**Henry VanLeeuwen
(Sub.)**

TO: MYRA MASON, PLANNING BOARD SECRETARY
FROM: MARK J. EDSALL, P.E., PLANNING BOARD ENGINEER
SUBJECT: VANLEEUEWEN MAJOR SUBDIVISION
PLANNING BOARD APPLICATION NO. 01-58

TOWN OF NEW WINDSOR
PLANNING BOARD
REVIEW COMMENTS

PROJECT NAME: VANLEEUEWEN MAJOR SUBDIVISION
PROJECT LOCATION: BEATTIE ROAD
SECTION 55 - BLOCK 2 - LOT 13
PROJECT NUMBER: 01-58
DATE: 10 OCTOBER 2001
DESCRIPTION: THE APPLICATION PROPOSES THE SUBDIVISION OF THE 4.1 +/- ACRE PARCEL INTO TWO (2) SINGLE-FAMILY RESIDENTIAL LOTS. THE PLAN WAS REVIEWED ON A CONCEPT BASIS ONLY.

FINAL PLAN
SECTION 55 BLOCK 2 LOT 13

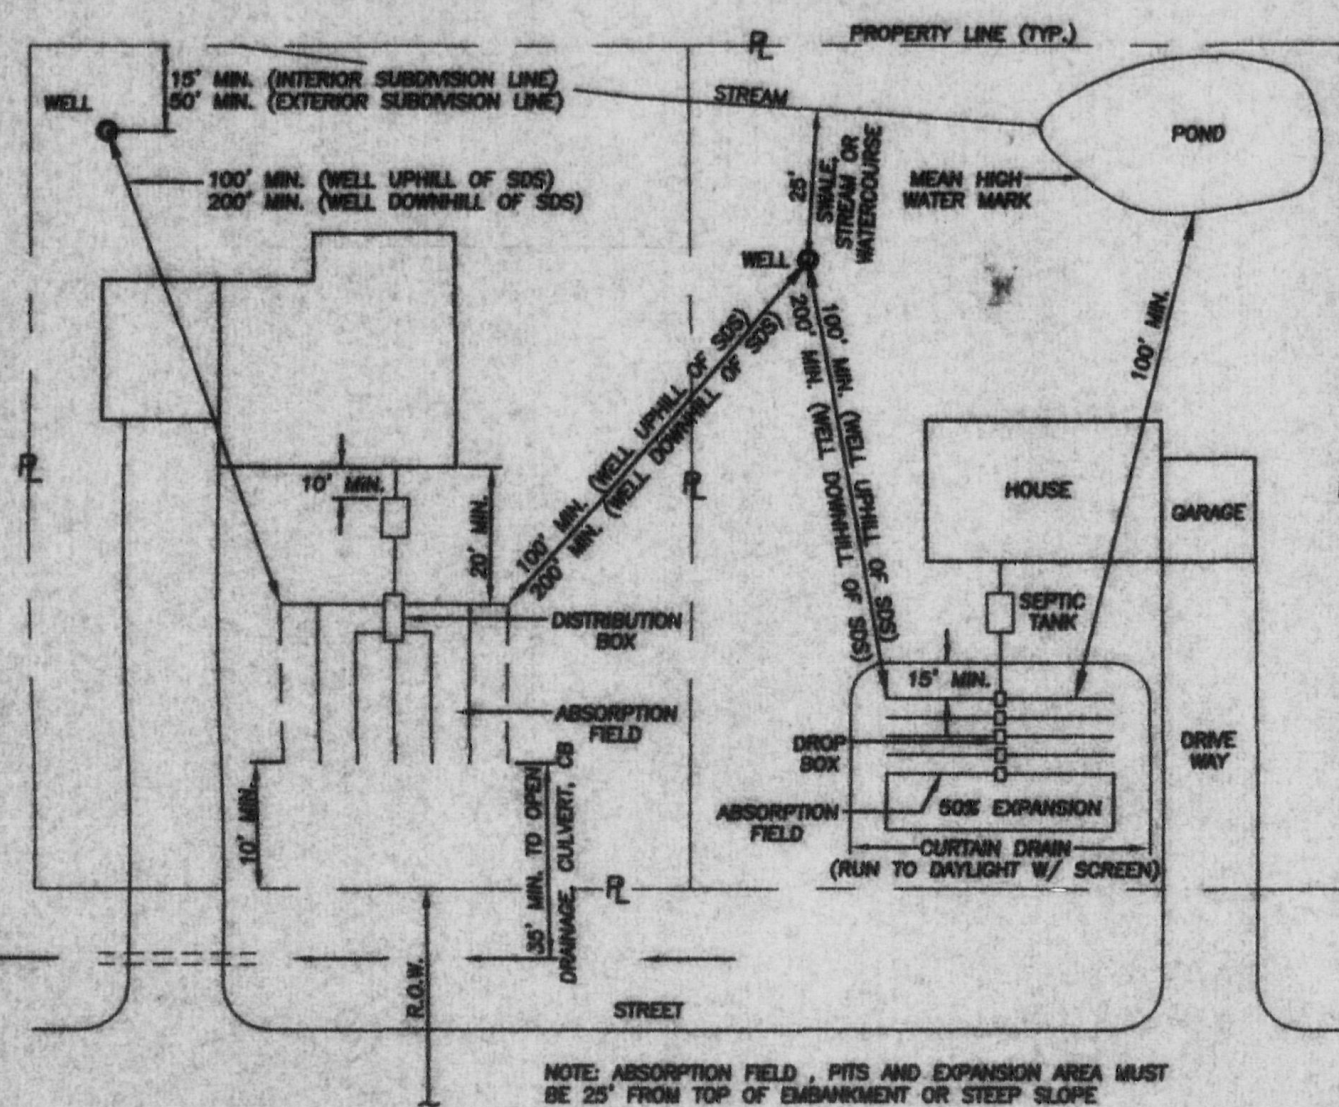
As per your request, I have reviewed the plan submitted for the subject application, with your received stamp date of 3 Dec 2001 (plan revision date 11-12-01).

Please note the plan is NOT responsive to my comments. Note the following:

1. The minimum livable area code requirement has not been added to the bulk table, as requested.
2. Adequate topographical data is not provided. It is acknowledged that several point elevations are shown; however, the engineer should have adequate points to generate a topographical depiction on the plan, such that compliance with State guidelines can be verified.
3. It was noted that the location of the SDS of lot #2 is critical, and should be further defined. The system location has been changed on the plan, but no indication is made by note or otherwise as to the basis of the "new" location. Clarify on plan.

The "required" values in the Bulk Table are correct, and each of the lots appear to comply with the minimum requirements. The table should include the "minimum livable area" value of the code.

2. I have performed my initial review of the plans and have the following comments:
 - a. The plan has no topography, which makes verification of proper SDS to well spacing impossible (spacing is based on direction of slope). Some topo information should be added.

- b. It is critical that the location of the existing SDS on proposed lot #2 (lot with existing house) be further defined, since it is shown approximate, but close to the legal minimum spacing to the property line. My concern is that if the system is any further to the southwest, it may be too close to the property line, or may end up on the adjoining property.

- c. Driveway locations will require approval from the Town Highway Superintendent.
3. The Planning Board may wish to assume the position of Lead Agency under the SEQRA review process.

MR. PETRO: Plan has no topography which makes verification of the proper SDS to well spacing impossible.

I received a corrected plan for the subject application (revision 12-6-01). The plan has addressed my comments, and is now acceptable.

In reference to the above project, enclosed please find twelve (12) paper copies and two (2) mylars, revised in accordance with the McGoey, Hauser and Edsall comments dated October 10, 2001 for signature. The specific revisions are as follows:

1. Spot elevations have been added to the plan to verify the proper distance between the well and septic system.
2. A field meeting with the applicant showed that the location of the existing SDS on the original plans was incorrect. The true location of the existing SDS has been added to the plans, showing more than the legal minimum spacing to the property line.
3. Approval will be sought from the Town Highway Superintendent regarding the driveway locations.
